Project Address
**24 Park Avenue, Camberley.
GU15 2NG**

Project Description
New Build

Sheet Title
Plans - Second Level - Proposed GA

Sheet Ref. **MAP-C4813-103** Rev. **0**

Proposed Second Level Plan
General Arrangement | 02-FFL | Scale 1 : 100

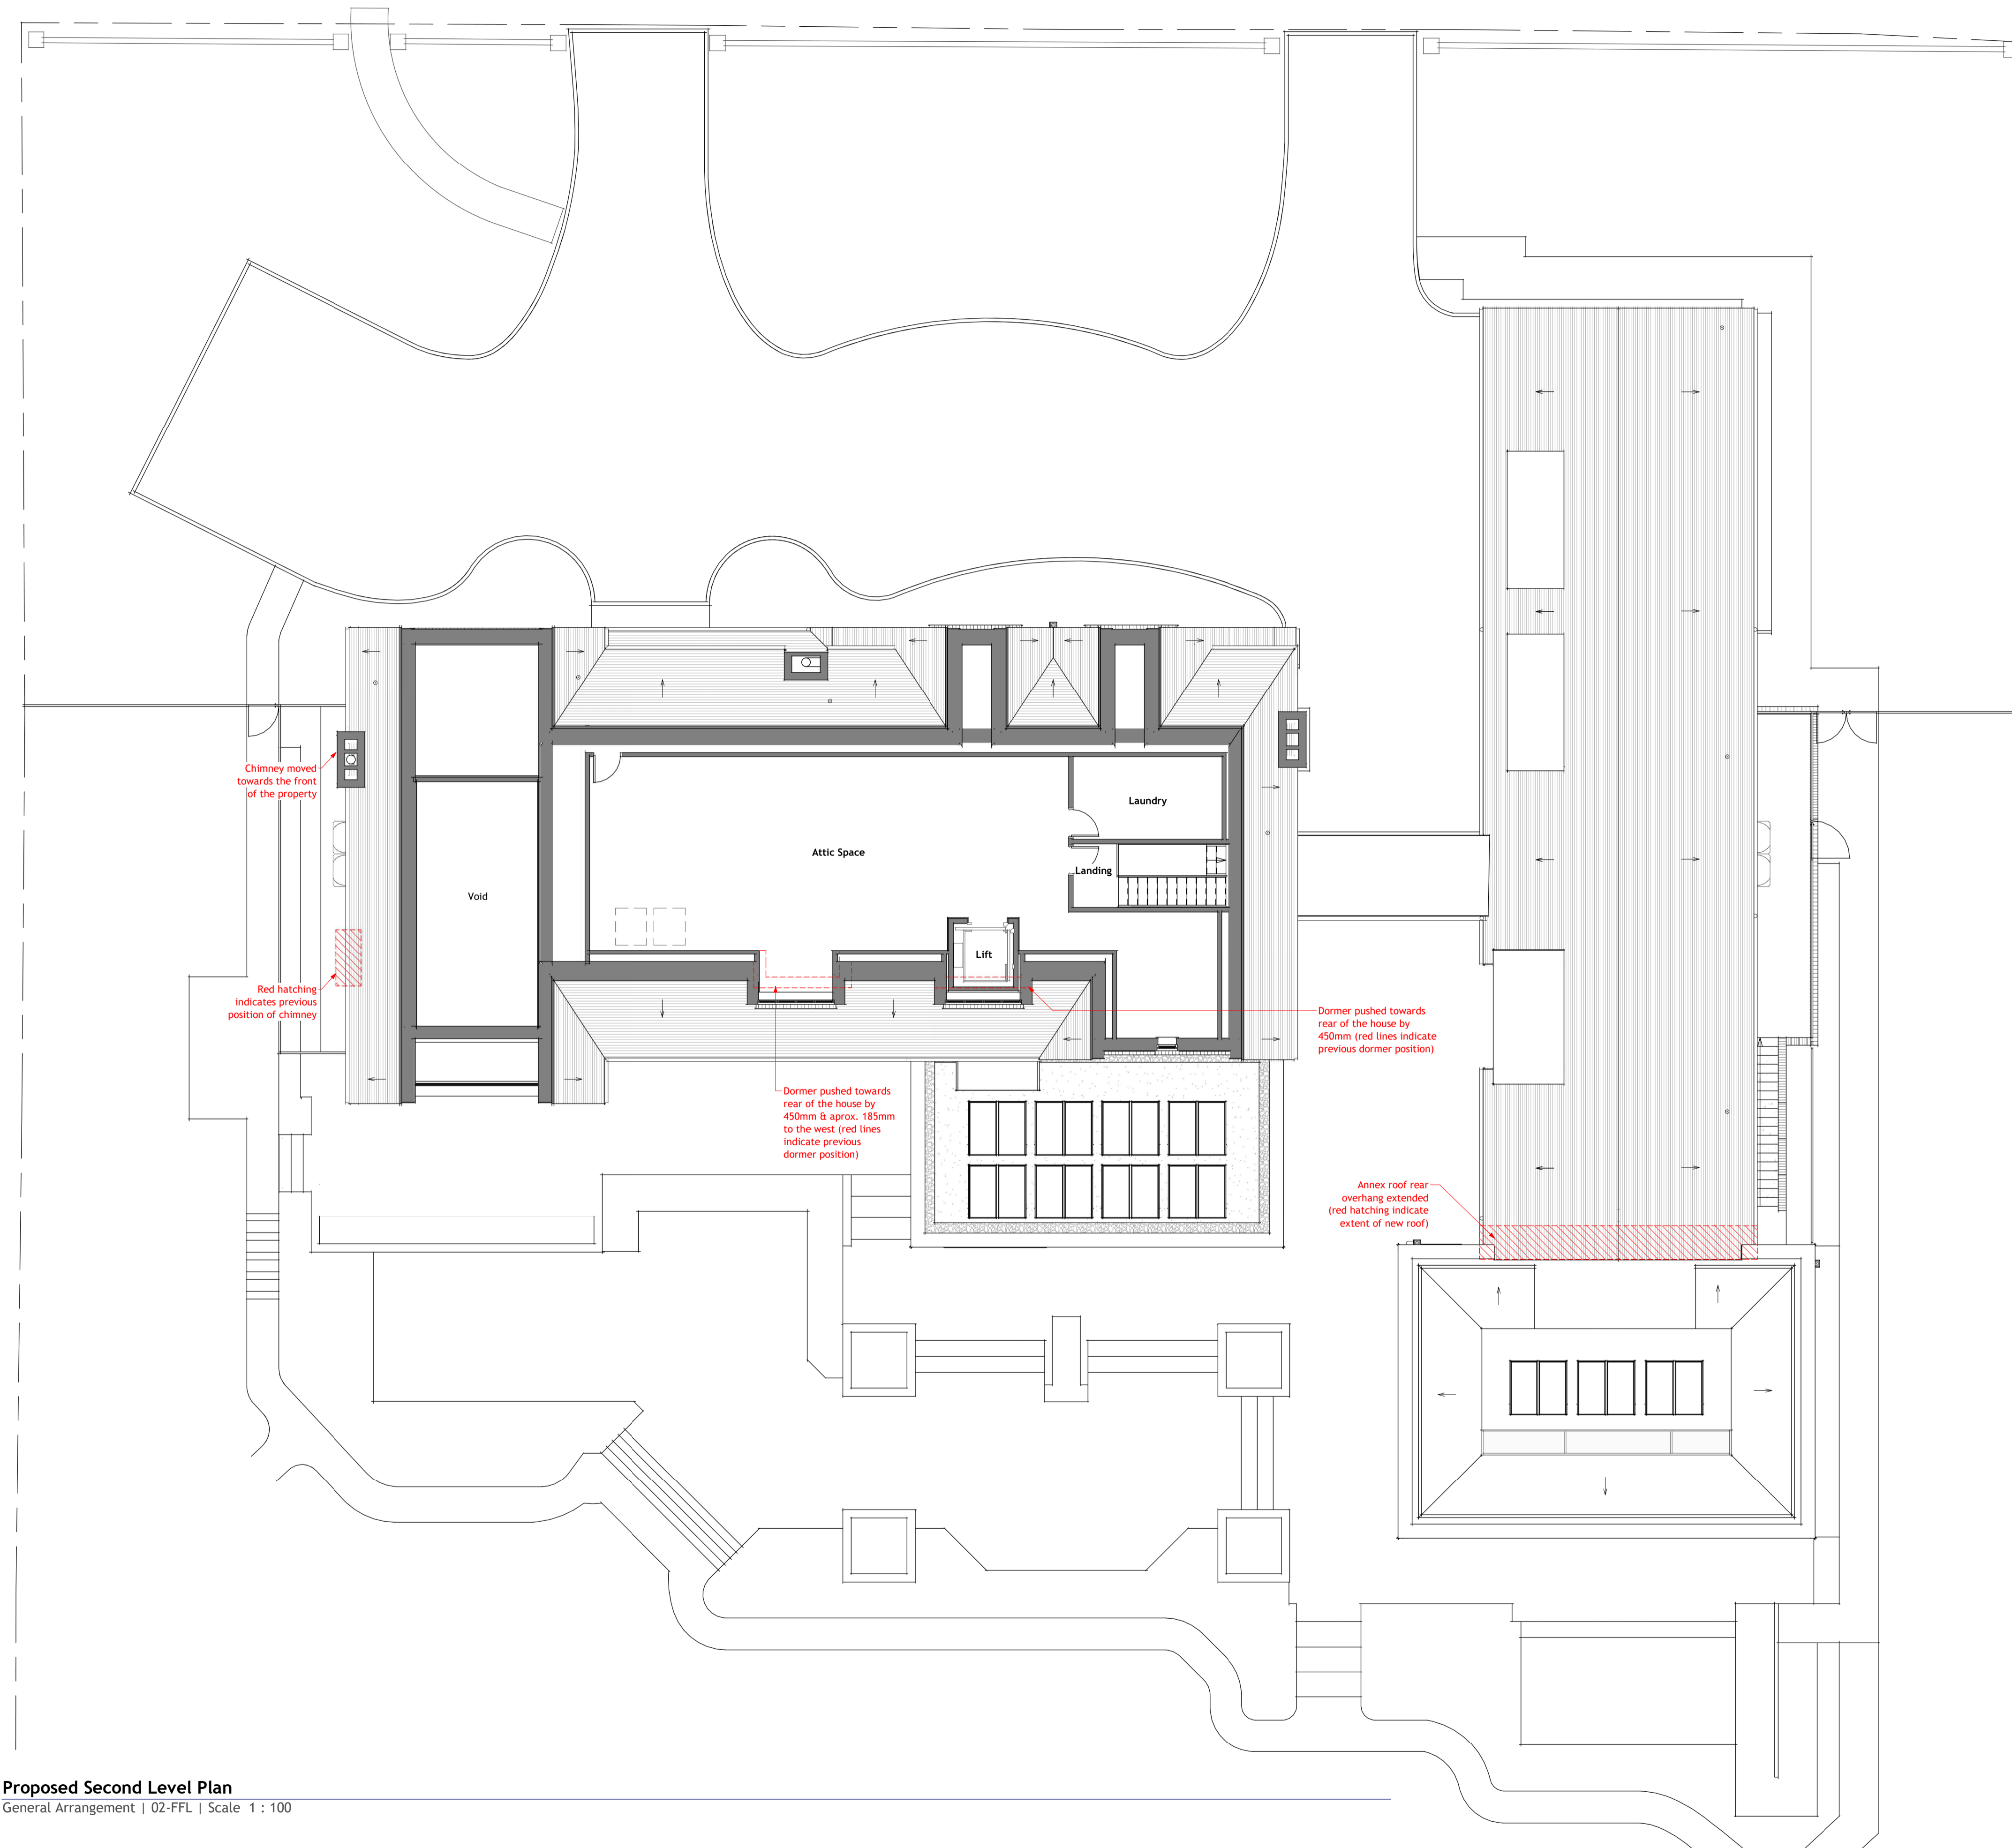
These drawings are for a non-material amendment application to the previously approved design, reference '22/1164/FFFU'. Changes annotated on the drawings & are as follows:

1. Windows size & position revised as shown on plans & elevations
2. Windows removed as shown on plans & elevations
3. New window in the east elevation of the house
4. West chimney moved towards the front of the house as shown on plans & elevations
5. Dormer windows position adjusted as shown on plans & elevations
6. House roof eaves raised & roof pitch reduced by 1No. degree as shown on elevations
7. 2No. rooflights added as shown on plans & elevations
8. Glass roof removed as shown on plans
9. Annex roof rear overhang extended as shown on plans & elevations
10. Annex East wall partly rendered behind fence as shown on elevations
11. Flat rooflight added as shown on plans
